## Appendix I – Table 2: Planning Map Changes – IHP RECOMMENDATIONS

### PC14 Council Reply – Information record of changes made to planning maps as part of S42A Reports, including corrections to memorandum already provided to the IHP.

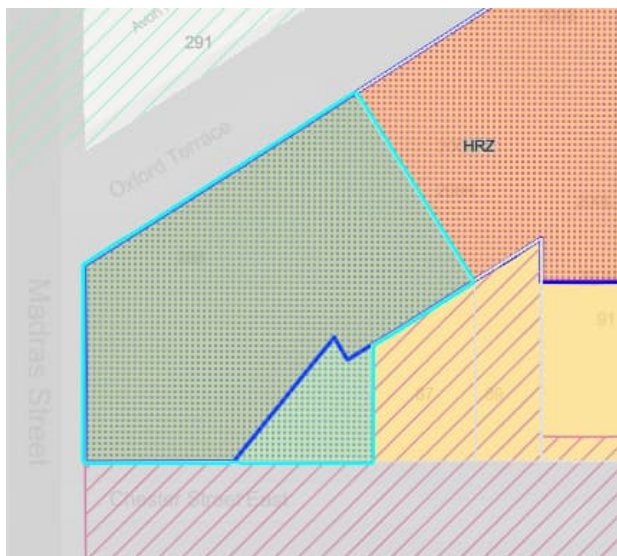
#15	Mapping	Panel request on 20.11.23 for conferencing on possible Ravensdown air	Residential properties within 240m of the Ravensdown Hornby site at 312 Main South Road retain their operative zoning of Residential Suburban.	The change to zoning due to a change to recommendation. Justification is set out in the Planners Joint Witness Statement (JWS)	<b>Notified:</b> MRZ with some HRZ.	Brittany Ratka	Revert to MRZ as per Parts 5 and 7 of the Report.

Entry #	Type	Source / Submitter(s)	Nature of additional change(s)	Reasons for change(s)	Notified & s42A Recommendation	S42A Officer	Panel Recommendation
		discharge buffer (Panel Information Request #58)		'Ravensdown Industrial Interface', and associated appendices, dated 18.04.24.	<b>Recommended in s42A:</b> MRZ with greater extent being HRZ (recommended by Ike Kleynbos).  <b>Right of reply:</b> RS zoning within 240m of Ravensdown Hornby site (312 Main South Road) as set out in Joint Witness Statement.
